MEMORANDUM

REVIEW TYPE: Preliminary Plan of Subdivision (Resubdivision)

PROJECT NAME: Hermitage
CASE #: 120080270
REVIEW BASIS: Chapter 50, Montgomery County Subdivision Regulations

Figure 2: Preliminary Plan

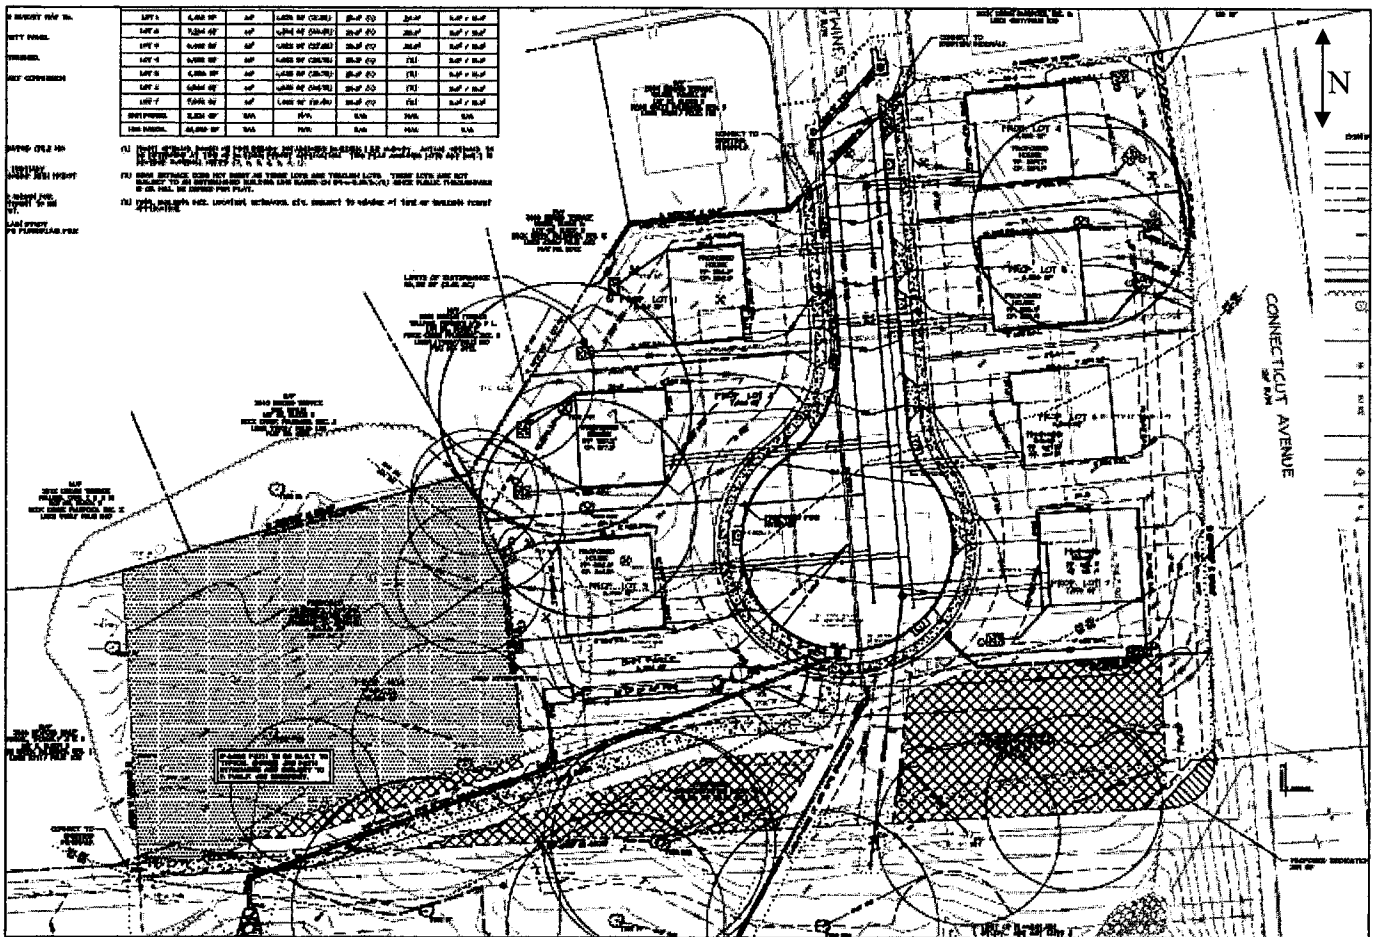
The Applicant proposes to extend Brandywine Street and terminate the road in a cul-de-sac that will serve 7 one-family detached dwelling units on 7 lots ranging in size from 6,008 square feet to 7,573 square feet. The 7 homes will be served by private driveways extending from Brandywine Street. There will be no vehicular access to Wexford Drive, but an asphalt path is proposed to connect Wexford Drive to the Brandywine Street cul-de-sac to enhance pedestrian connectivity to Rock View Elementary School located north of the site on Denfeld Avenue. This asphalt path will be constructed to County shared use path standards in the location of the existing driveway to the swimming pool. A public use and access easement will be required to ensure community accessibility. In some places this public use and access easement will overlap with required storm drain easements. A Category I forest conservation area is proposed along the southern and western Property boundaries.

Wexford Drive is not being extended and Brandywine Street, an existing secondary residential street, is proposed to be extended by the Applicant as the point of access for all proposed lots. Sixty feet of right-of-way is currently provided for Brandywine Street north of the Subject Property with a 26-foot paved roadway and 5-foot wide sidewalks on both sides of the street. The Applicant, with concurrence from MCDOT and M-NCPPC Transportation Planning Staff, proposes to dedicate 50 feet of right-of-way for the extension of Brandywine Street into the Property but will maintain 26 feet of pavement width and 5 foot-wide sidewalks that will connect to existing sidewalk north of the site. Brandywine Street will terminate in a standard, 90-foot diameter paved cul-de-sac and will not connect to Wexford Drive.

After weighing all the options, MCDOT staff and MNCPPC Transportation Planning Staff agreed that a trail connection across Connecticut Avenue was not feasible in this location but connecting Wexford Drive to the Brandywine Street cul-de-sac and thus providing greater mobility options for neighborhood residents to Rock View Elementary School was still a desired improvement. The Applicant's proposal to provide an asphalt path utilizing the existing driveway for the swimming pool to the greatest extent possible will best minimize impacts to the stream valley buffer on the site. As a result, the preliminary plan depicts an 8 foot-wide path to be built to County shared use path standards in a 20 foot-wide private path and storm drain easement that connects sidewalk along the Brandywine Street cul-de-sac to existing sidewalk along Wexford Drive. The path will not be public because it will not meet ADA standards due to the slope of the Property in this location.

- 3) The record plat must reflect a Category I easement over all areas of stream valley buffers and forest conservation.
- 4) The applicant must dedicate and the record plat must show dedication for the extension of Brandywine Street within the property as a 50 foot-wide right-of-way ending in a 110 foot diameter cul-de-sac as shown on the preliminary plan.

- 6) The Applicant must construct an 8 foot-wide shared use path from Wexford Drive to the proposed Brandywine Street cul-de-sac built to County standards as shown on the preliminary plan. The record plat must reflect a public use and access easement over this path.
